# VOLLMER ROAD (BARBARICK)

## STREET IMPROVEMENT PLAN

90% PLAN SET - NOVEMBER 2021

VOLLMER ROAD  
(BARBARICK)  
COVER SHEET

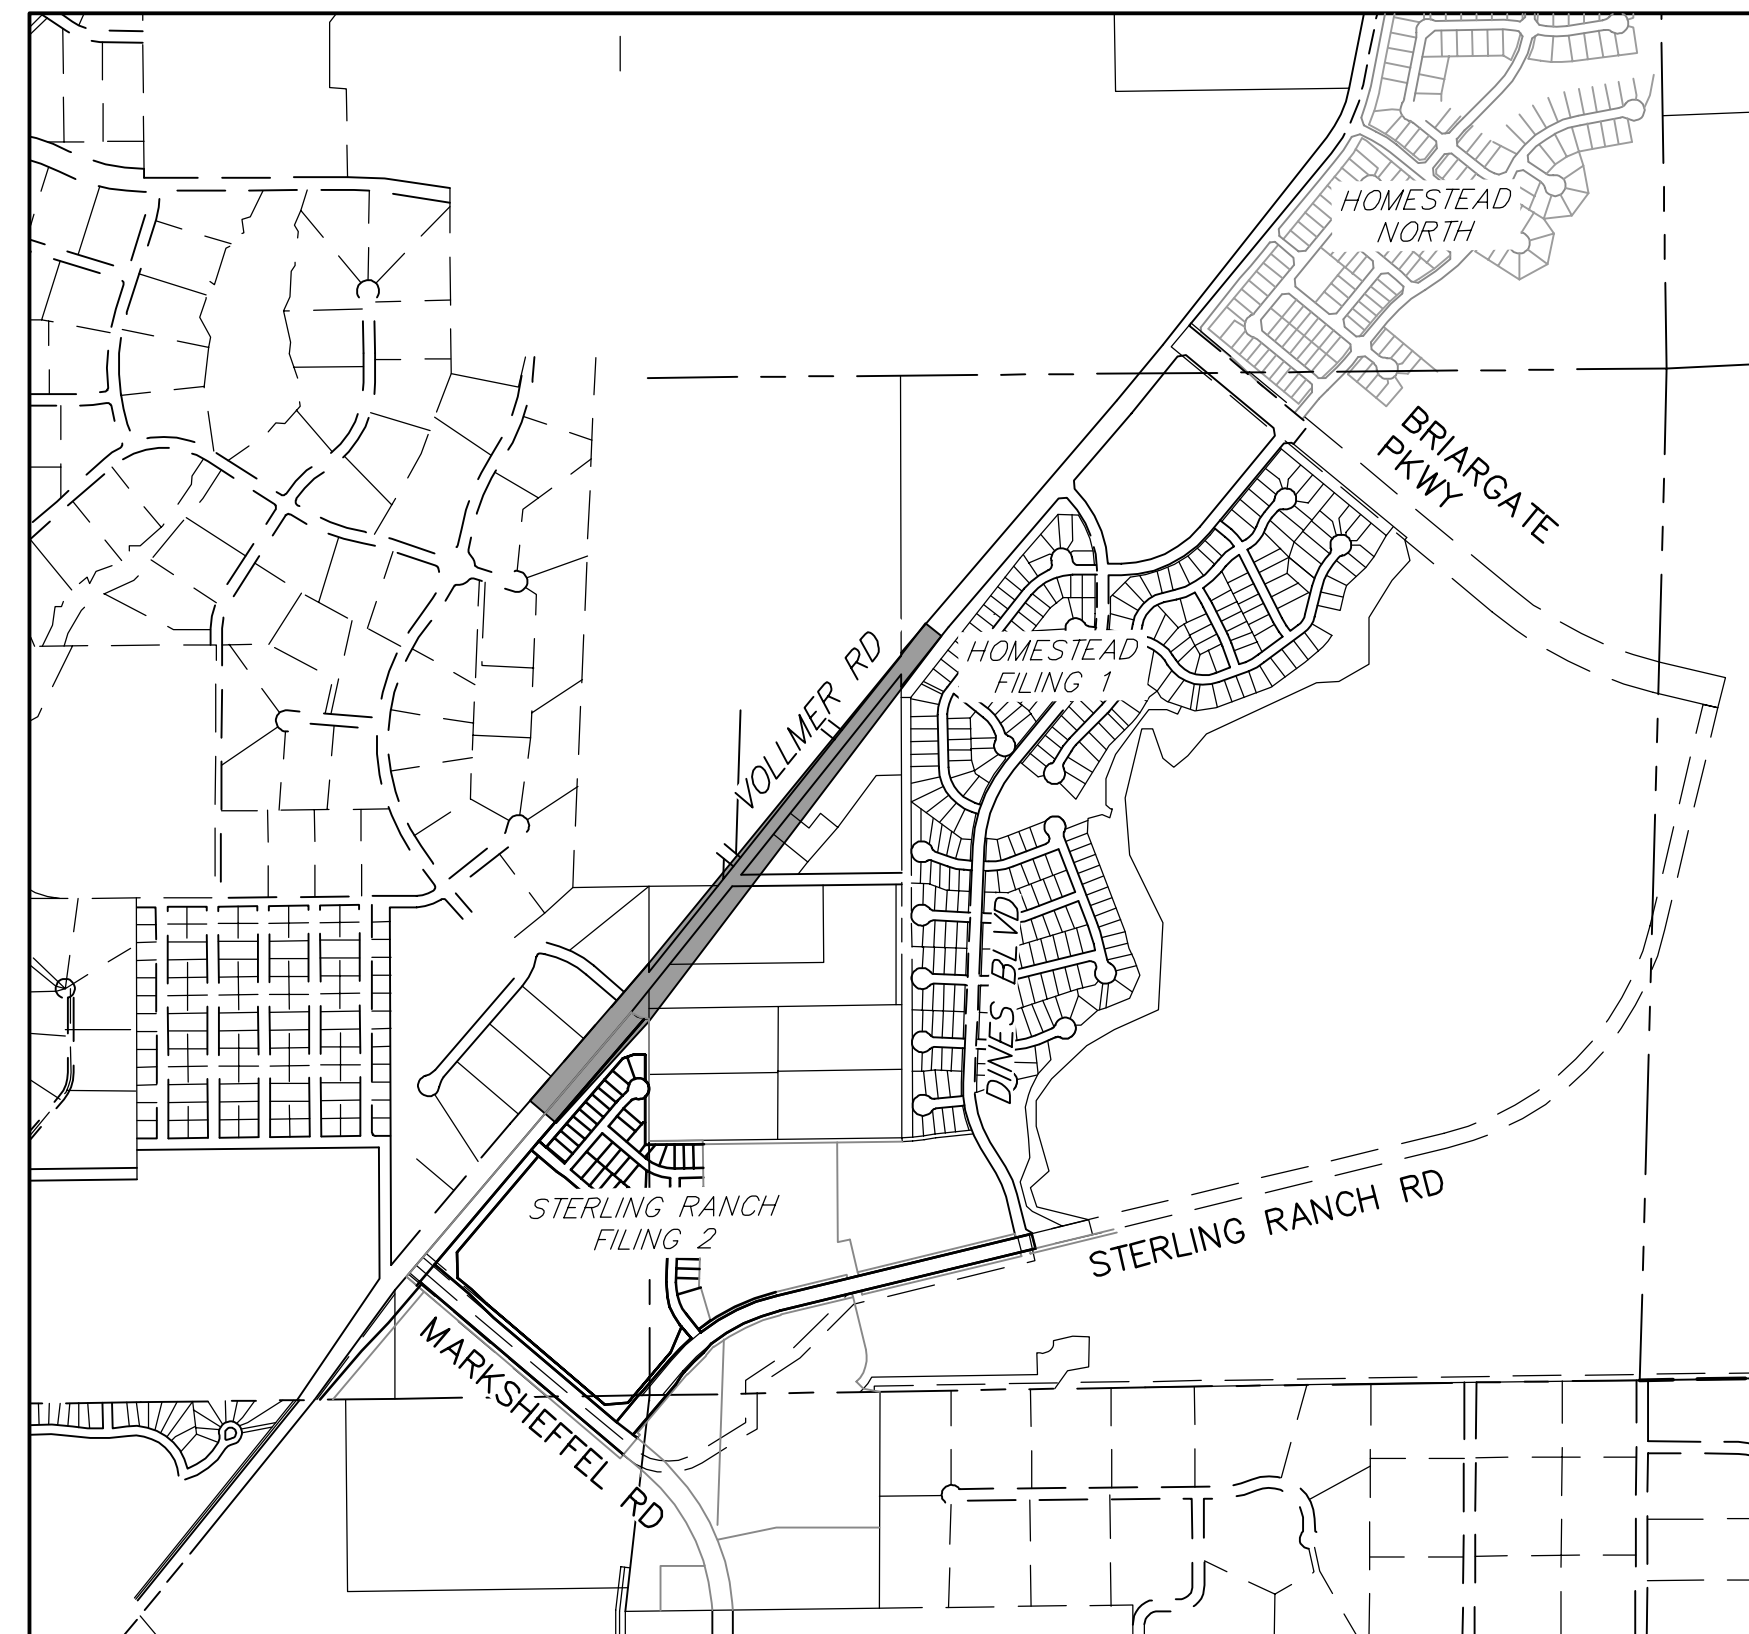
Will need a grading and erosion control plan to go along with this plan set.

Include Basis of Bearings

Add "PCD File No. CDR-21-10"

VOLLMER ROAD (BARBARICK)  
NOTES AND DETAILS

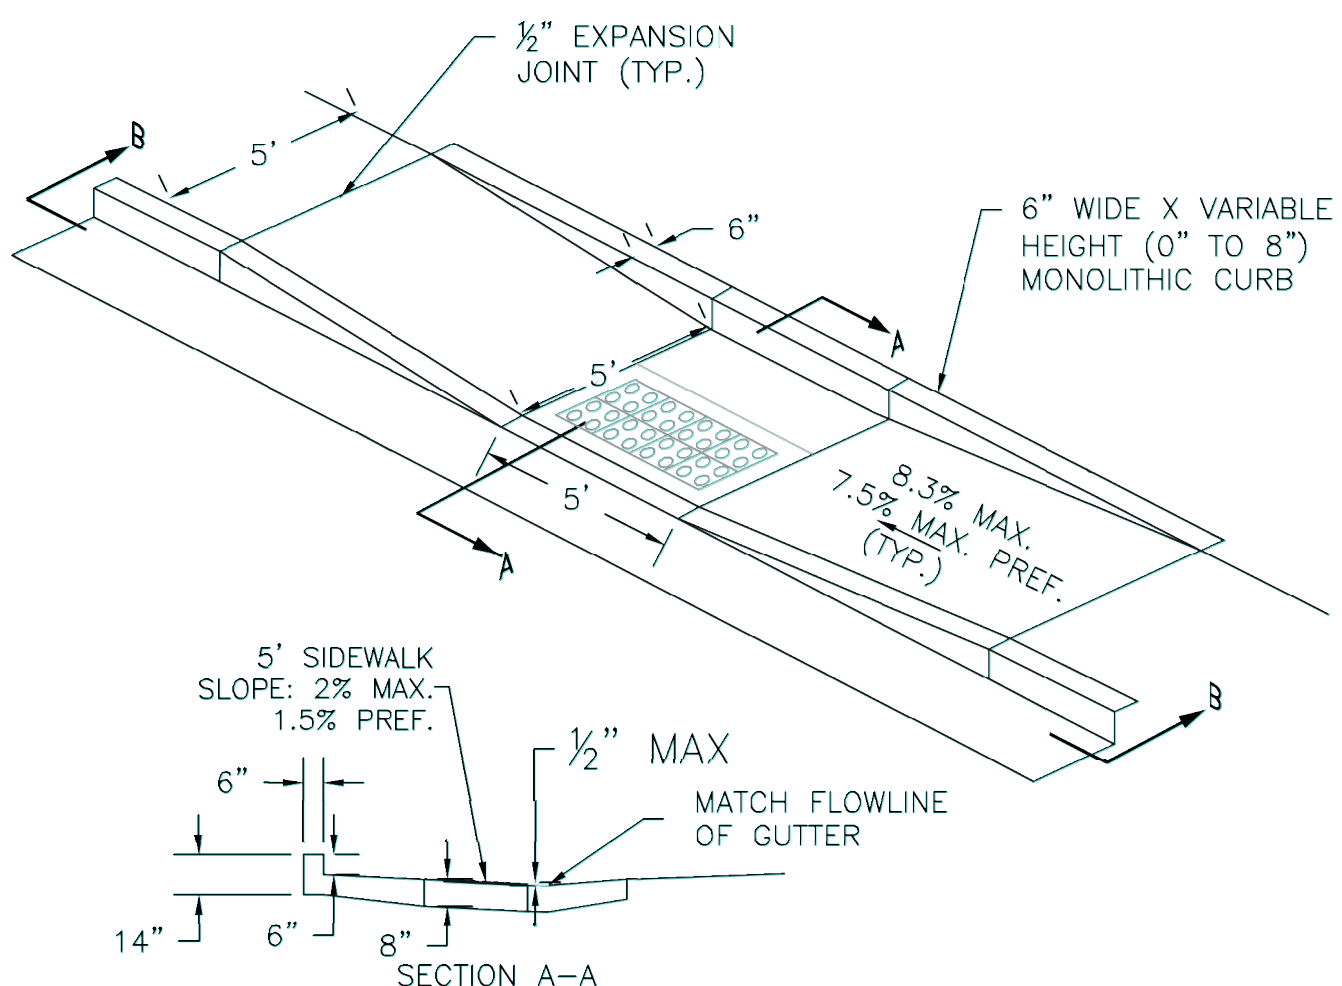
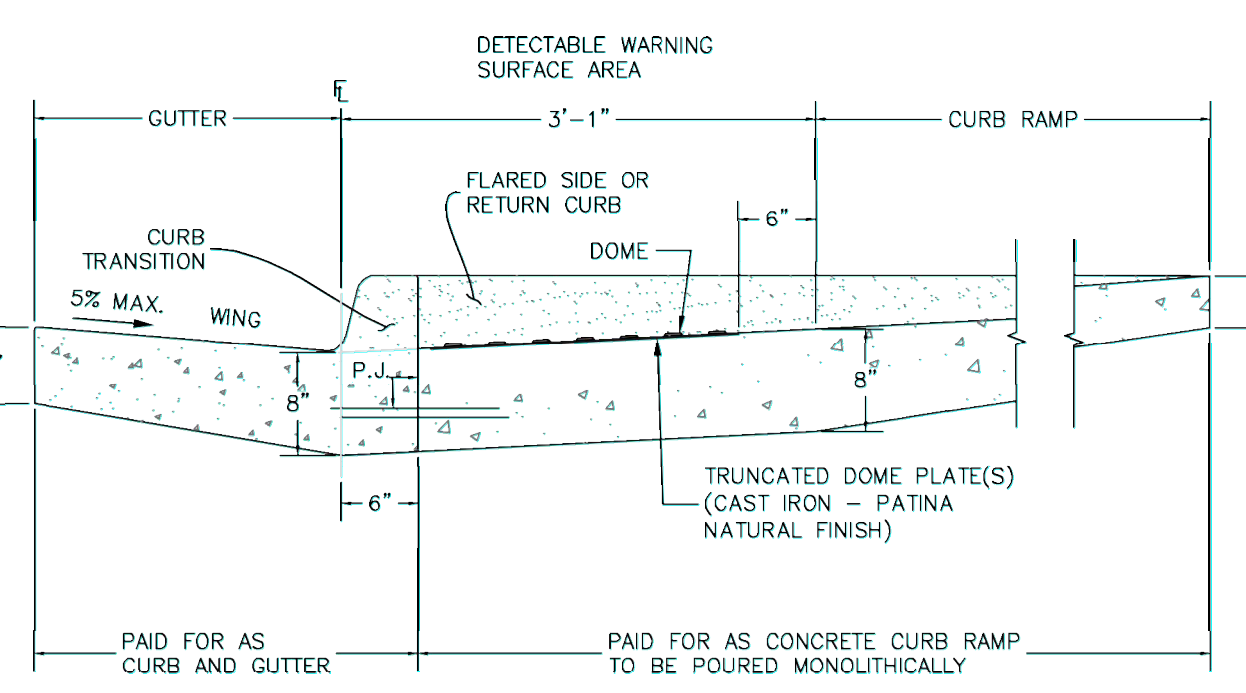
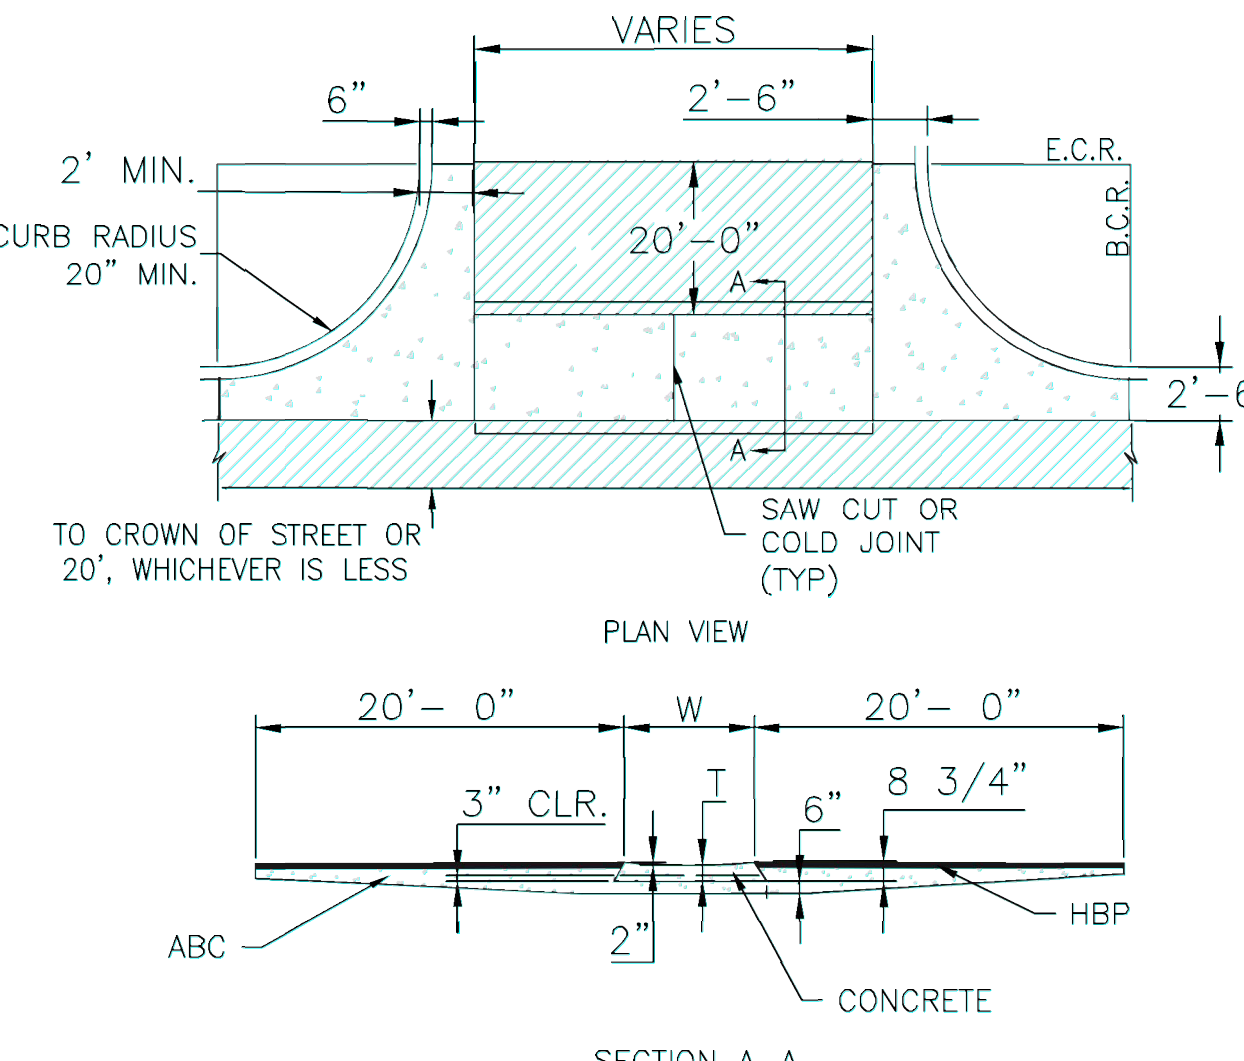
Include county driveway detail (SD-2-23)  
Include EPC standard signing & striping notes.

VOLLMER ROAD BARBARICK SECTION PROFILE (1)  
STA 27+00.00 TO 36+50.00

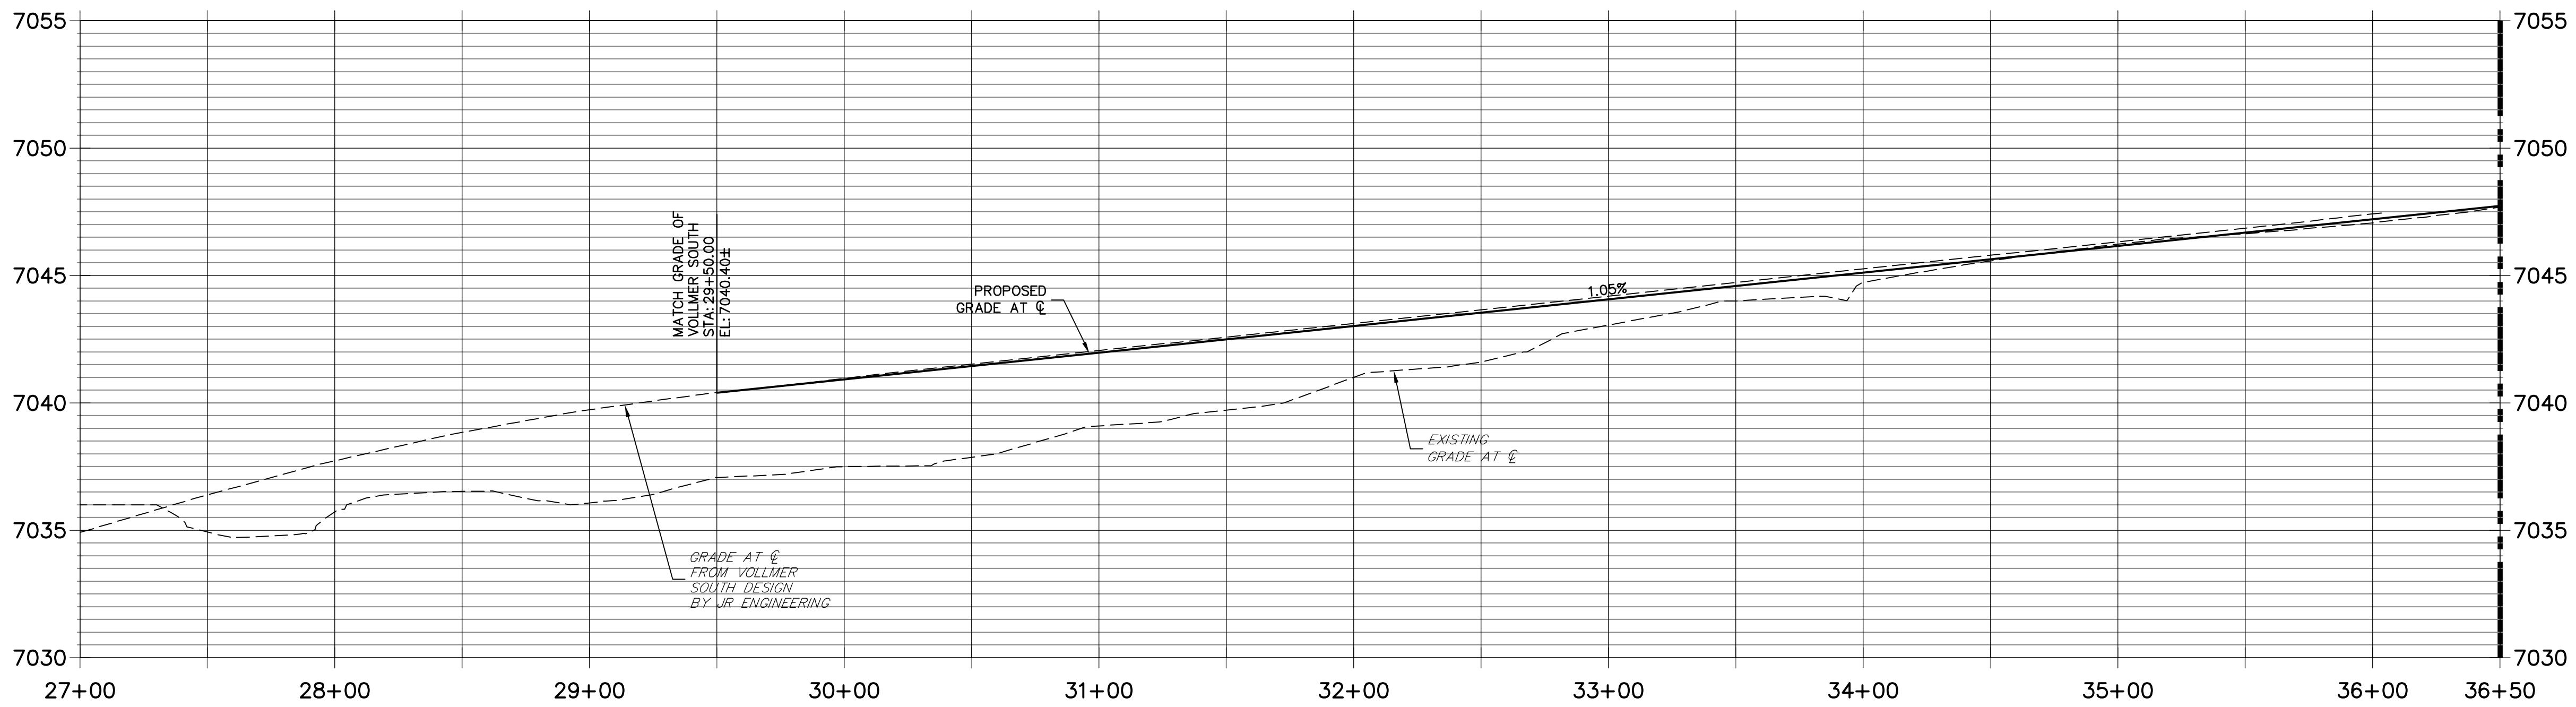
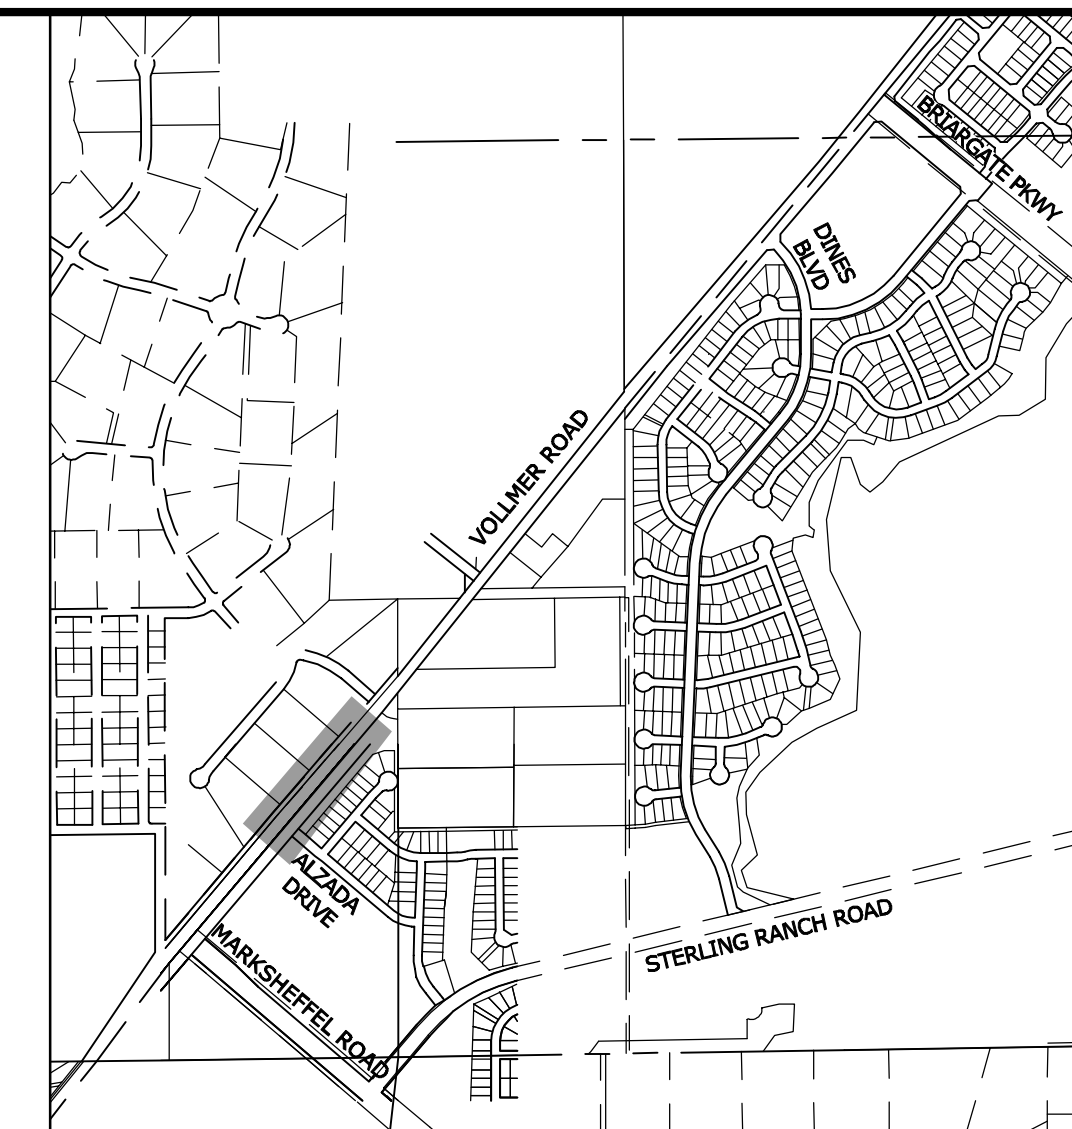
Include linetypes used in legend
